**Before the Hearings Panel
at Porirua City Council**

In the matter of the Proposed Porirua District Plan

**Statement of evidence of David Allen Sullivan on behalf of Kenepuru
Limited Partnership**

Date: 19 November 2021

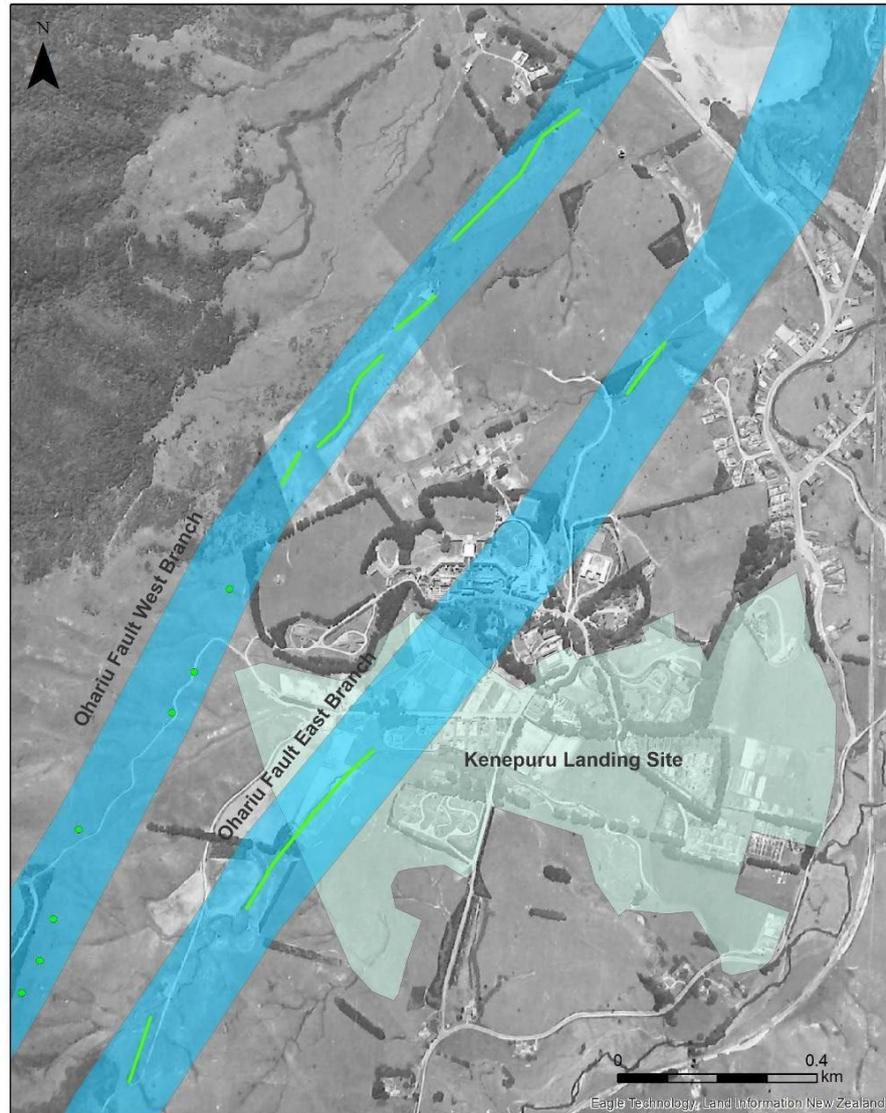
18.1 *The east branch of the Ohariu Fault passes through the Kenepuru Landing Site, and the Fault Rupture Zone in the PDP is based upon the FAZ developed by Litchfield and Van Dissen (2014) and is 170 m wide (Figure 1)².*

18.2 *I have reviewed the data used by Litchfield and Van Dissen (2014) to define the FAZ in the vicinity of the Kenepuru Landing Site. These data are shown in Figure 1 and are stream alignments on 1940s aerial photographs in the southwest part of the site (Mitchell Stream) and ~650 m northeast of the site. The location across the remainder of the Kenepuru Landing Site was considered uncertain in large part because of extensive ground surface modifications associated with the former Kenepuru Hospital.*

19 Response to 18.1: Noted, and referenced in Coffey report.

20 Response to 18.2: No intrusive investigations were undertaken by GNS within the vicinity of the Kenepuru Landing Site. The data noted in Figure 1 was utilized as the basis for the detailed fault study.

client:	KENEPURU LP		
project:	KENEPURU SUBDIVISION PORIRUA		
title:	FAULT TRENCH SUMMARY		
project no:	773-WLGGE198865AE	figure no:	01
rev:	D

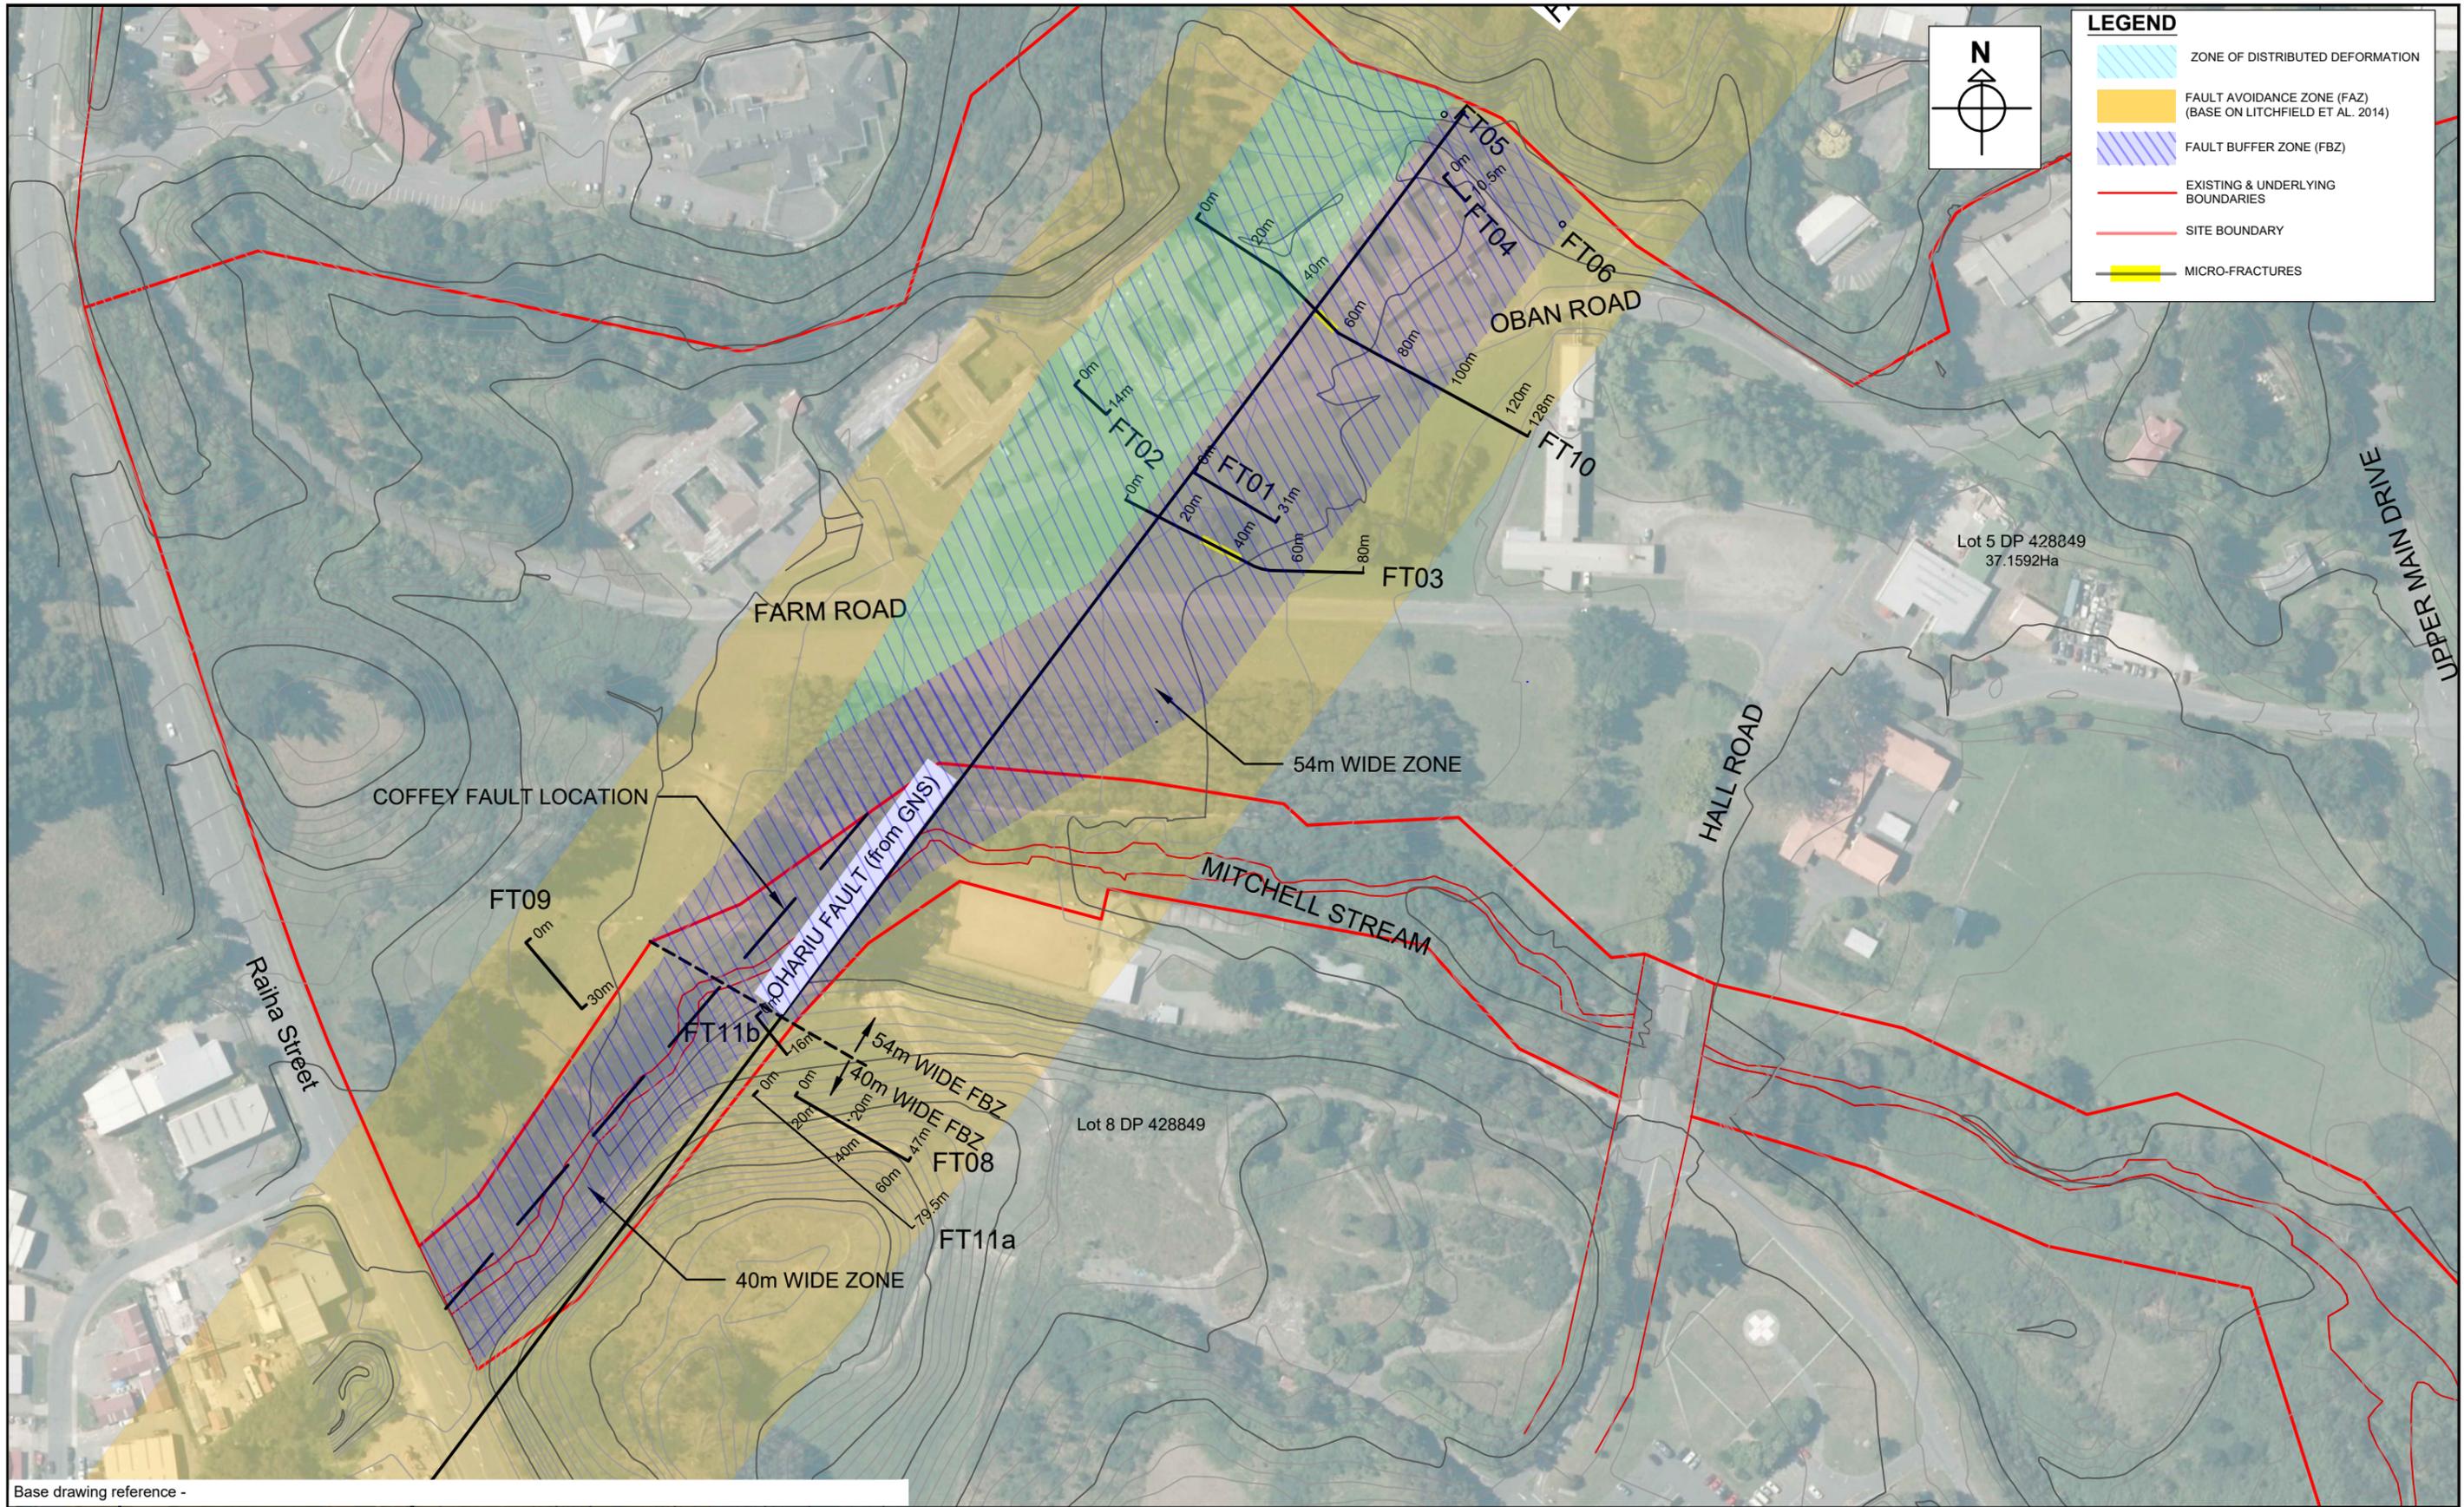
report by J Begg Geo (2020) supplied by Council. Coffey propose a Fault Buffer Zone that is 40 m wide in the south (Mitchell Stream) and 54 m wide in the centre and north (Figure 2). They have also proposed a Distributed Deformation Zone adjacent to the northern Buffer Zone.

19.1 *The Coffey southern Fault Buffer Zone is defined by the current centreline of Mitchell Stream and a 20 m buffer either side. I consider this zone to be too narrow for several reasons:*

1) Mitchell Stream in this area appears to have been modified (moved northwest) from the presumed natural location on the 1940s aerial photographs;

2) The centreline doesn't take into account the sinuosity of the stream and therefore the related uncertainty of the fault location;

3) The use of a centreline (rather than an uncertainty zone) implies that the Ohariu Fault is of 0 m width, contrary to the northern Fault Buffer Zone; and

4) it is my opinion that trenches FT09 and FT11b were too

shallow, with a base in alluvium (FT09) and silt (FT11b) that could be younger than the most recent metre-scale surface rupturing earthquake on the Ohariu Fault (1050-1000 years ago; Litchfield et al. 2004, 2006, 2010). Therefore, I consider the presence of the Ohariu Fault below the base of these trenches cannot be ruled out.

- 23 Response to 19.1-1: We agree the stream has been modified, however, it is located at the base of the hill slope, and most likely has been pushed south-east as fill has been placed. It is not possible for the stream to have been located further to the south east due to the presence of the adjacent hill. The fault line (Litchfield & Van Dissen, 2014) located through the hill is not possible based on the geology and observations (Coffey report reference 773-WLGGE198865-AG-Rev2 dated 2 July 2019) after subsequent removal of the adjacent hill top.

- 25 Response to 19.1-2 and 19.1-3: The centre line is an indicative line for drawing and presentation purposes (it is also dashed to imply uncertainty). It is not intended to represent the sinuosity of the stream or the width of the fault. It should be noted GNS active fault database utilizes a standard width line to represent all faults, regardless of fault width, location, depth of soil cover or structure. We acknowledge this as a requirement of drawing / web mapping.

- 27 Response to 19.1-3: As noted above, there is no suggestion that the fault is 0m width. the width of the fault is unknown as it has not been identified

- 28 Response to 19.1-4: For trench location 11b this was undertaken after the top of the hill was removed with excavation up to 8m in height. Following excavation trenches 11a and 11b were excavated to provide a clean surface for inspection. 11a is in the order of 8m+ in depth from the original surface. The soils in 11b are old residual soils and is meters in depth below the original surface. Noted it reduces to 0m at the slope edge. The soils predate the Holocene period. The trenches were also inspected by Doug Mason from WSP, and the interpretations are in agreement. The geology of the hilltop adjacent Mitchell Stream should be considered ‘greywacke’. FT09 – the depth in the trench was limited by ground water, gas pipelines and property boundary.

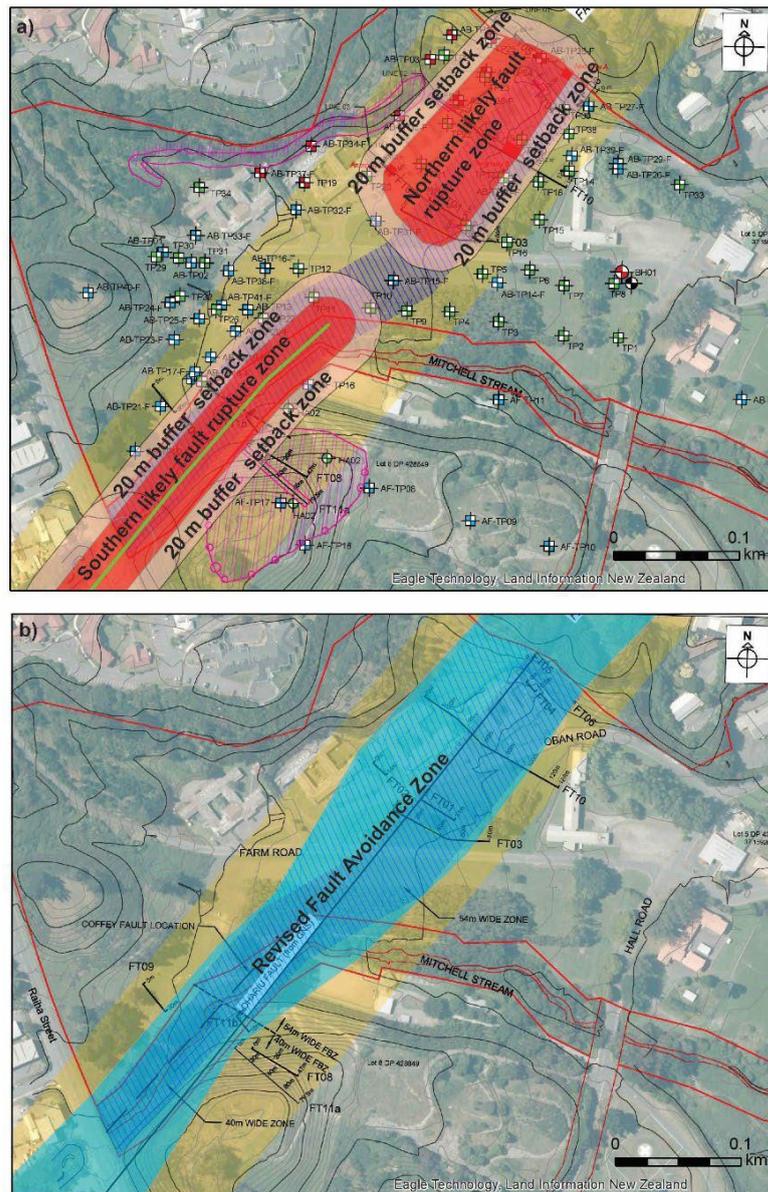
45 Dr Litchfield then recommends that *"the eastern Ohariu Fault FAZ through the Kenepuru Landing Site could be revised as identified in Figure 3. The revision uses the methodology and some data from Litchfield and Van Dissen (2014) and the Coffey data that I consider to be robust enough to use to define a FAZ."*

In the south a likely fault rupture zone (red) is constructed from a buffer either side of the Mitchell Stream trace mapped by Litchfield and Van Dissen (2014) from the 1940s aerial photographs (green line). The buffer is 22.25 m wide (noting that this may change slightly if the Coffey survey/GIS data could be obtained) constrained by the western end of FT11a (Figure 3a), which was entirely in bedrock and did not show any clear evidence of recent faulting. In the absence of any other information the same width is used on the west side of the fault. A 20 m buffer setback zone (pink) is then added either side, but this is modified on the east side to again meet the western end of FT11a. Thus, the total revised FAZ width would be 64.5–84.5 m, which is wider than, but does encompass, the Coffey Fault Buffer Zone (Figure 3b). It is narrower than the 170 m wide zone in the PDP.

In the north, a likely fault rupture zone (red) is constructed that is bound by the outer edges of (from top right to top left): geophysical anomaly A, geophysical anomaly B, the outer edge of the total zone of microfractures in FT03, geophysical anomaly C, and a step in bedrock in FT10. This step has not been identified as a fault, and could be a terrace riser, but the trench was not deep enough to rule it out as a fault scarp. The final (northernmost) point is projected along the same orientation. A 20 m buffer setback zone (pink) is then added either side. The total width of this revised FAZ is 101–119 m, similar to, but slightly wider than, the combined Coffey Fault Buffer and Distributed Zones (Figure 3b), but narrower than the 170 m wide zone in the PDP.

Between the two areas, the revised FAZ is joined with straight lines, and is also tapered to the existing FAZ

been aspects directly relating to the study of the eastern branch of the Ohariu Fault. The cumulation of several years of investigation and assessment resulted in the development of the peer review report: Coffey Services NZ Ltd, 'Kenepuru Subdivision – Fault Trench Investigation – Assessment Report', dated 26 May 2021. The findings of that work concluded the following:

21 Response to 18.3: GNS recommendations regarding the methodology were incorporated. This can be seen in the depth of trenches and trench photos. GNS were contacted on numerous occasions both during the trenching and GNS were requested to undertake the peer review. Refer to attached emails. No one from GNS visited site during trenching. Russel Van Dissen was contacted and request to undertake the peer review but noted at the time they did not have the availability due to heavy work load on the NSHM.

- 50 However, we are in general agreement with the northwest side of the proposed southern rupture zone, but believe the 20m setback buffer should be moved to the area of the 0m end of FT08 and FT11a. It is noted that FT11b did not observe rupture.
